**FINAL PRODUCT/PROCESS CHANGE NOTIFICATION #16819**

**TITLE:** Qualification of Serial SPI EEPROM devices CAT25128 and CAT25256 for fabrication at ON Semiconductor's Gresham, Oregon Wafer Fab.

CAT25128 UDFN-8(HU4)

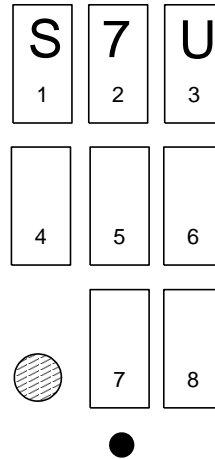
- 1-3: Product Code
- 4: Assembly Location Code
- 5-6: Assembly Lot Number
- 7: Production Year
- 8: Production Month
- : Pb-free microdot

CAT25256 PDIP-8 (L)

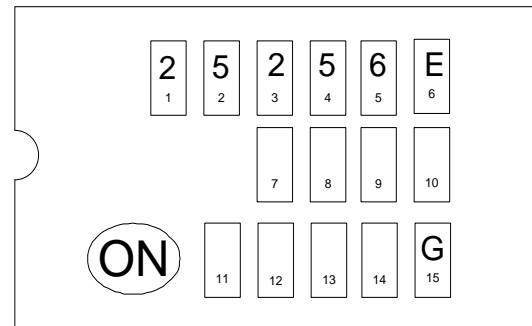
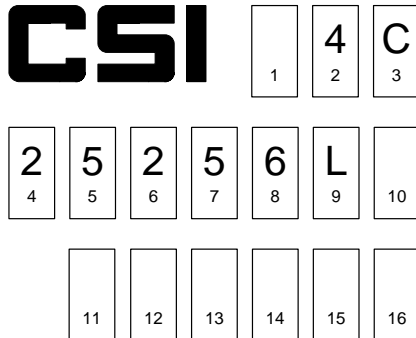
- 1: Assembly Location Code
- 2: Lead Finish (NiPdAu)
- 3: Product Revision
- 4-9: Product Code
- 10: Temp Range
- 11: Production Year
- 12: Production Month
- 13-16: Assembly Lot Number

- 1-5: Product Code
- 6: Product Revision
- 7: Assembly Location Code
- 8-10: Assembly Lot Number
- 11-12: Production Year
- 13-14: Production Week
- 15: Pb-free designator
